RE: Docket ID NRC-2016-0231

In its review of the application by Interim Storage Partners, LLC, (ISP) for a license to construct and operate a consolidated interim storage facility (CISF) for spent nuclear fuel in Andrews County, Texas, it is respectfully requested that the Nuclear Regulatory Commission (NRC) consider the remarks provided below.

Exhibit 2

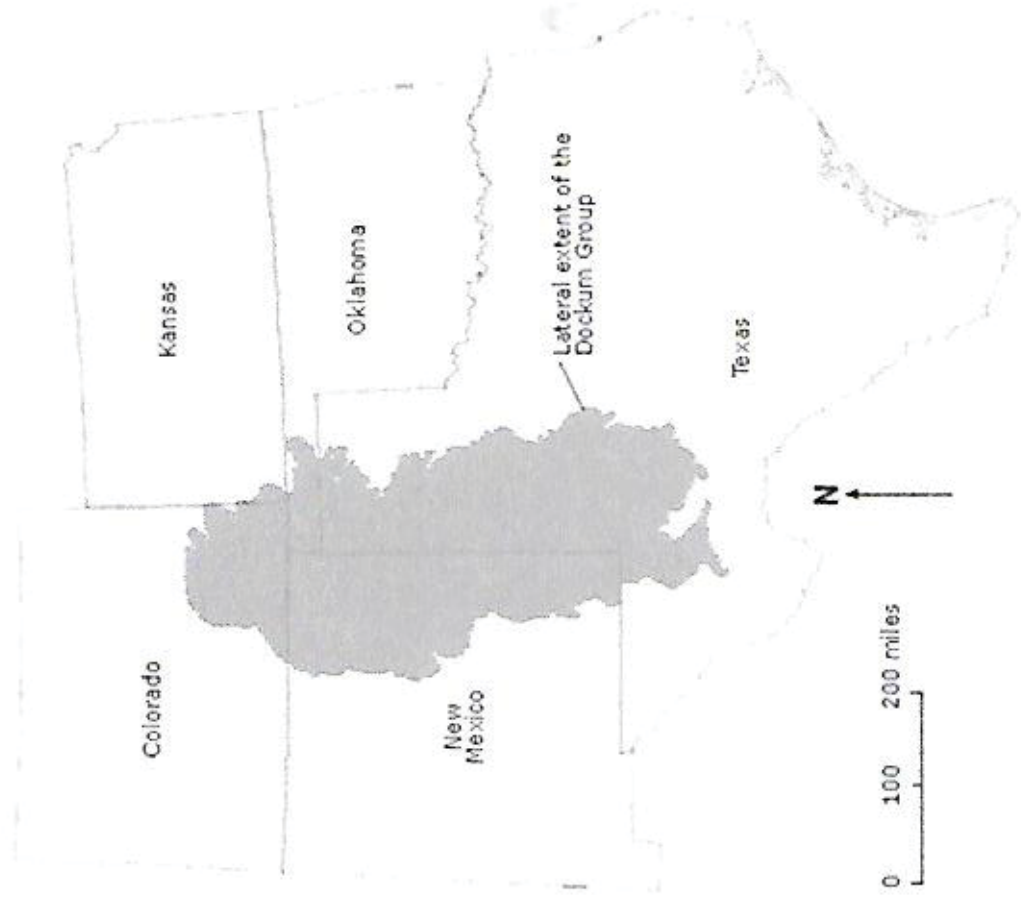
Attached as Exhibits 2 thru 8 are PowerPoint slides from the first reference noted by Mr. Robinson and mentioned in the previous paragraph that when considered together flatly contradict the self-serving statements offered by ISP and its associates. Exhibit 2 shows a map on the left side of the page showing the lateral extent of the Dockum aquifer into Texas and three other states. The Dockum aquifer is shown to extend north-south along the Texas-New Mexico boundary where the proposed CISF is located. The aquifer surrounds the proposed CISF on all sides. Exhibit 3 shows that there are approximately 200-250' of net sand in the Lower Dockum at the proposed CISF. Exhibit 4 shows there is about 0-10' of net sand in the Upper Dockum at the proposed CISF site. Exhibits 3 and 4 together show that both upper and lower Dockum aquifer sands are regional features that are continuous and cover thousands of acres including the entirety of Andrews County, Texas, where I reside. Exhibit 5 illustrates that wells drilled into the Dockum aquifer in Andrews County are capable of producing water at a rate of 10-1000 gallons per minute. Exhibit 6 illustrates that total dissolved solids in the Dockum aquifer water in Andrews County can be expected in the 1000-5000 mg/L range – a range capable of treatment by conventional processes like reverse osmosis to produce potable water --

EXHIBIT 7

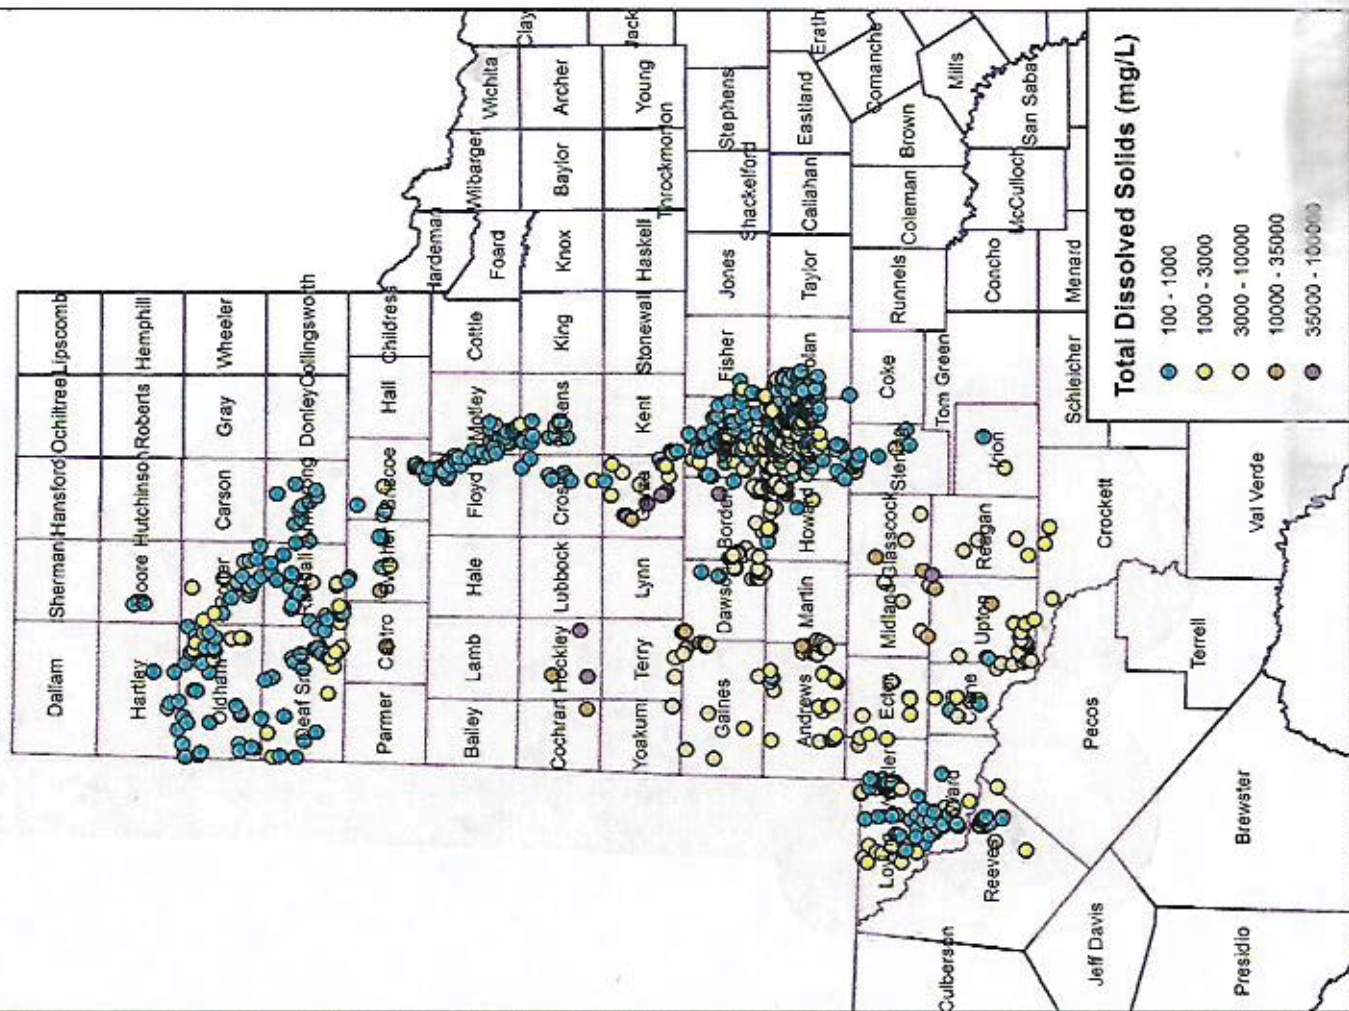
at the proposed CISF. Exhibit 7 backs up the data of Exhibit 6 showing Dockum test wells in Andrews County producing water with total dissolved solids ranging mostly from 1000-3000 mg/L. Exhibit 8 provides an overview of Dockum aquifer statistics. It is worth noting that with 27 million acre-feet of brackish water estimated to be in place according to Exhibit 8, the Dockum aquifer would provide the city of Andrews with water for 1200 years at its current rate of consumption of about two million gallons a day if the city merely recovered 10% of the brackish water in place. This suggests that the Dockum aquifer may be the "go to" water resource as the Ogallala aquifer plays out in the coming years.

EXHIBIT 10

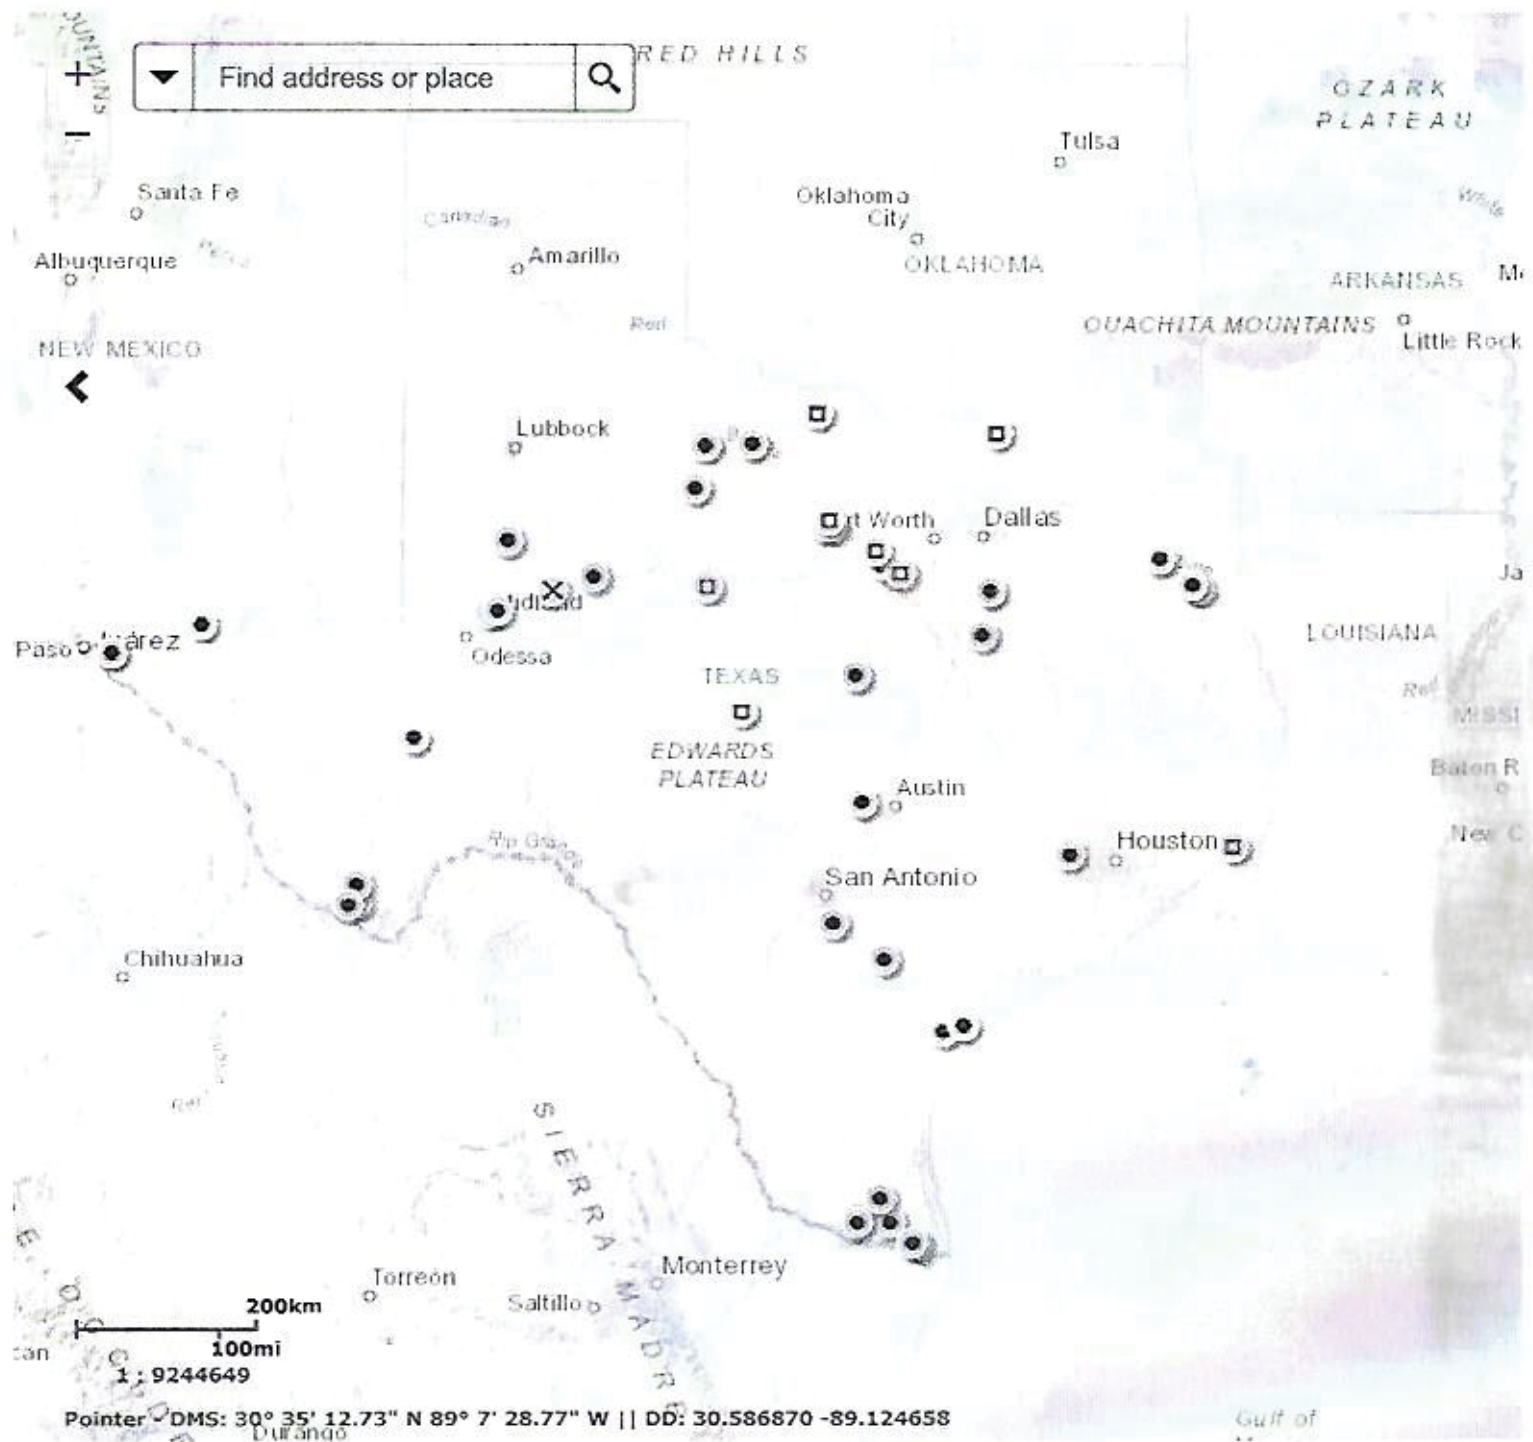
The city of Seminole is not alone in desalinating brackish water in Texas according to the TWDB. Exhibit 10 is a copy of a map from the TWDB website showing about forty active, desalination plants around the state of Texas. Some of these plants can be seen in West Texas not far from the proposed CISF. It would not be unreasonable for communities surrounding the proposed CISF to desalinate and consume groundwater flowing from the proposed CISF at some point in the near future. The entry of radionuclides into this water from the proposed CISF might render it unfit for human consumption.
